4. Stormwater management

4.1. The developer's stormwater management plans are not credible.

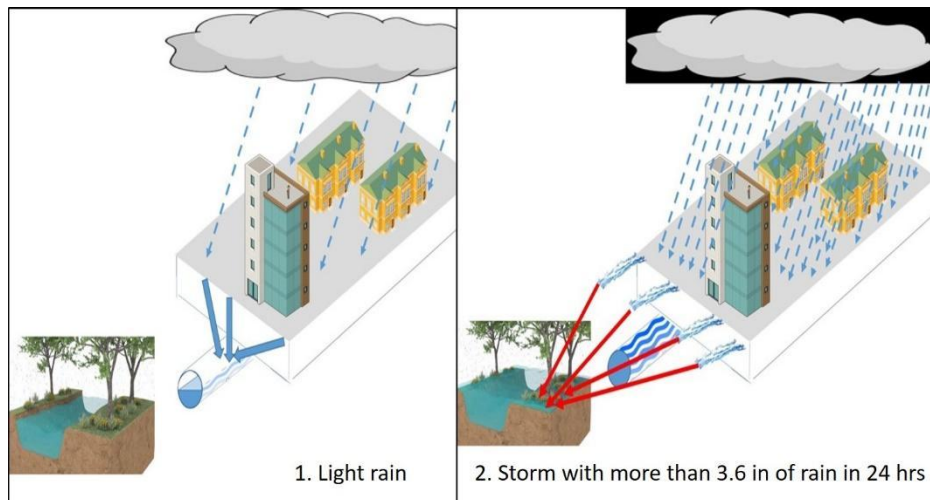
A simple calculation based on the capacity of the proposed stormwater storage vault and the area of impervious surface proposed by Gilbane, shows it would be filled with heavy rain and the excess would run off directly into the stream much more frequently than an average of 100 years. The amount of rainfall that would fill the proposed storage vault and overflow directly into Guilford Run (Figure 2) is simply the capacity of the vault (said to be 1 million gallons) divided by the area of new impervious surface (10.14 acres) (assuming 100% runoff from the impervious area). After conversions to the same units, the depth of rainwater that would fill the vault is 3.6 inches. This assumes that the vault is not partly filled before the rain and that it is fully drained before the next event - which could be in the next 24hrs.

More appropriate data come from the nearest meteorological stations and include the past 20 years. The realistic frequency of rainfall events can be found by reviewing the rainfall records to find the frequencies of 3.6 inches or more. In Table 1, the results for Beltsville and Hyattsville are shown. The capacity of the proposed storage system would have been exceeded 14 times since 2000. The average frequency of 3.6 inches or more rainfall was once every 3 – 4 years – far more frequent than Gilbane's statement that, on average, the rainfall that would fill their system is once every 100 years. The outdated NOAA Atlas 14, shows the 100yr flood is 8.45 inches in 24hrs, far beyond the capacity of the proposed system.

Figure 3. Development increases the volume and rate of runoff from a site, and reduces groundwater recharge and evapotranspiration. Growth and water resources, Watershed Academy Web, Environmental Protection Agency,

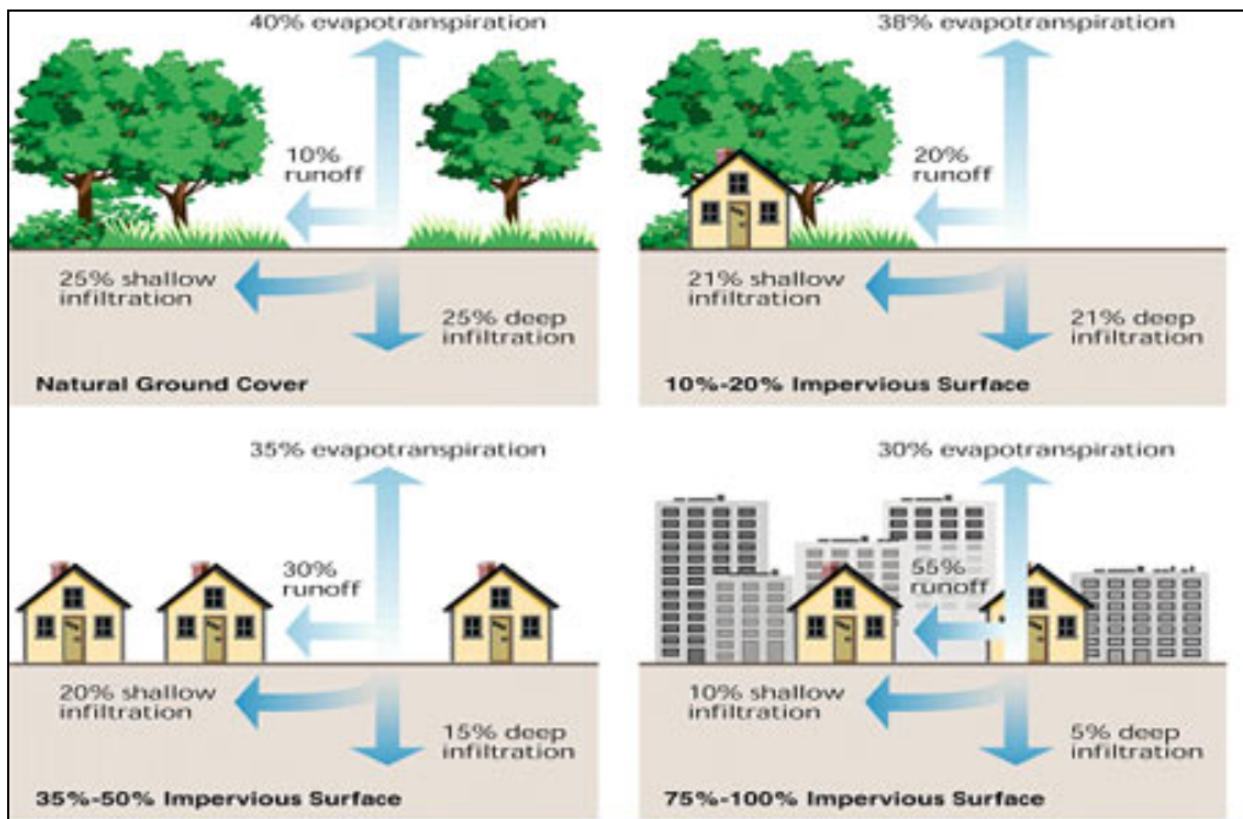
Gilbane's stormwater system misses key elements of the movement of water across a landscape, both in the sources and subsequent dissipation. Only on a continuous, impervious surface, such as a road, does rainfall simply run off, as allowed in Gilbane's plan (Figure 3, 75-100% impervious). In most natural conditions, including Guilford Woods, there are more components, both in the sources of stormwater and the subsequent flows. By overlooking these, the development plan is fundamentally unrealistic, erring on the side of minimal impact of the development on the stormwater flow in Guilford Run.

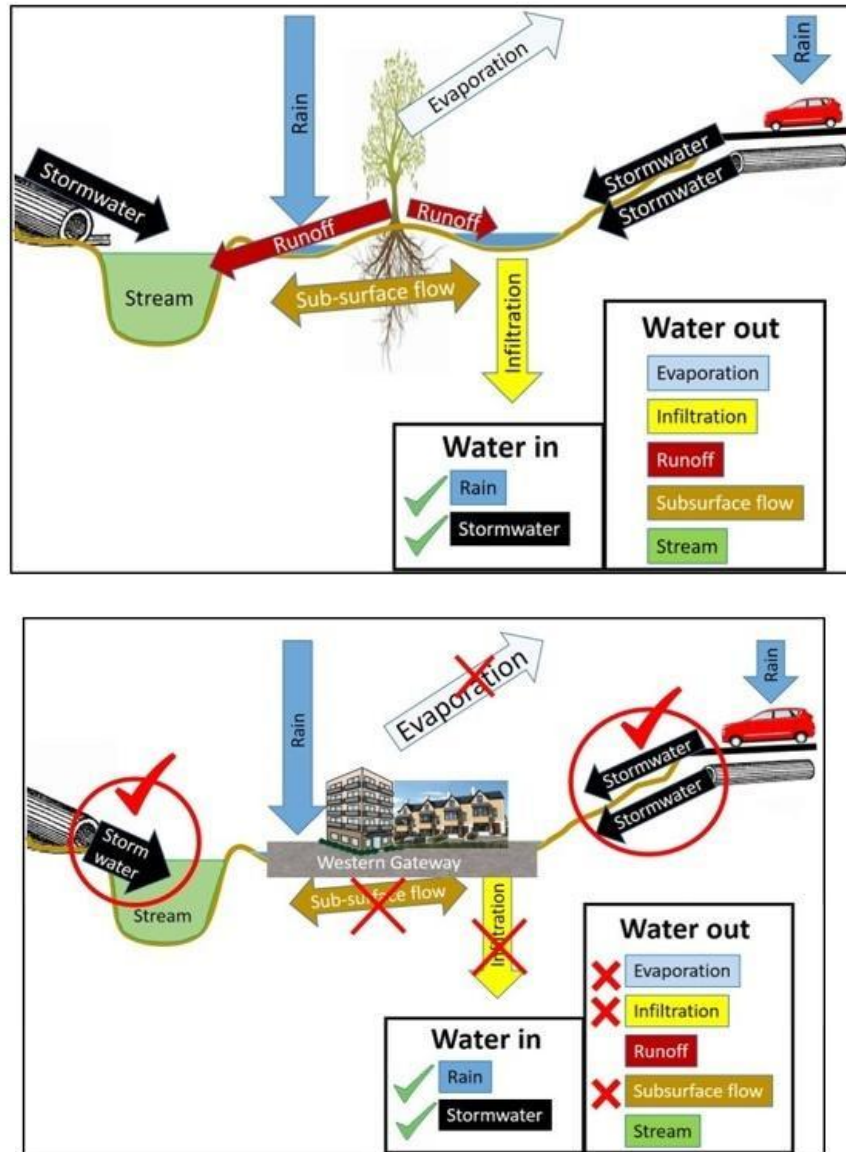
There are three key elements of the natural drainage system in Guilford Woods that will be negatively affected by the development and will have large effects on the flow in Guilford Run. These are the sources of water that flows into the Woods, evapotranspiration by the vegetation, and loss of infiltration sites (Figure 4).

Large stormwater pipes enter the Woods. These drain: the east side of Adelphi Road and buildings above the Woods; the large parking lots along Campus Drive; from Mowatt Lane; and large inputs from the University campus. In the past, the Woods have been treated as part of the public stormwater system, used for disposal of runoff from surrounding areas.

Importantly, the stormwater pipes terminate at the margins of the Woods, at significant distances from Guilford Run. At present, water that enters the Woods from these pipes largely infiltrates in temporary pools before much of it reaches the stream (Figure 5). Many small depressions impede the flow (Figure 6) and small wetlands form around the infiltration sites. However, the new impervious surface in the development (10.14 acres) will cover up many of the existing, natural infiltration depressions (Figure 4), so this runoff from outside the Woods will not infiltrate as it does now. Instead, the runoff will be diverted directly into the stream, forming new drainage ditches that will discharge water directly into Guilford Run, with no check. Peak flow rates will be increased (Figure 2.ii). The importance of infiltration in the current hydrology is indicated by the relatively high infiltration capacity of the soils (Figure 7). All except the soil type along the stream are well to moderately well-drained. This is in direct disagreement with Gilbane's repeated claim that the soils are mainly clay and infiltration is minimal.
